PAC611

Torch Insulator Upgrade

Field Service Bulletin
802330 - Rev. 0

Revision 0 September, 1995

Figure 6 Removing Torch Insulator from Quick Disconnect

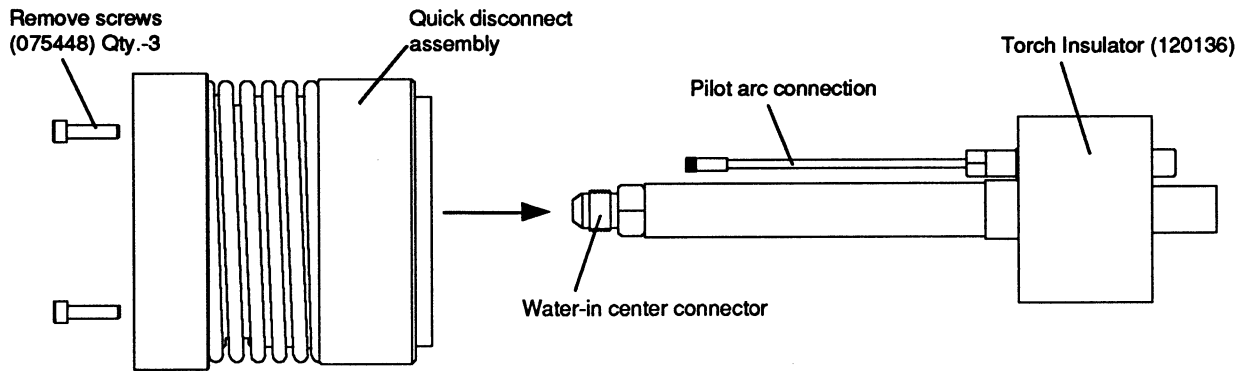
This upgrade will correct the problem of retaining rings popping off of the quick disconnect sockets when sockets are rotated. The modified insulator now has a groove in its internal wall to allow for clearance of the retaining rings when sockets are rotated.

2. Remove 3 screws (075448) that connect torch insulator (120136) to quick disconnect assembly. Torch insulator with attached pilot arc connection and water-in center connector will fall out easily.

1. Take new modified torch insulator and install in quick disconnect assembly by reversing instructions in this bulletin. Note: Replace all retaining rings with stainless steel retaining rings supplied with this upgrade.
2. PAC611 torch insulator upgrade is complete.
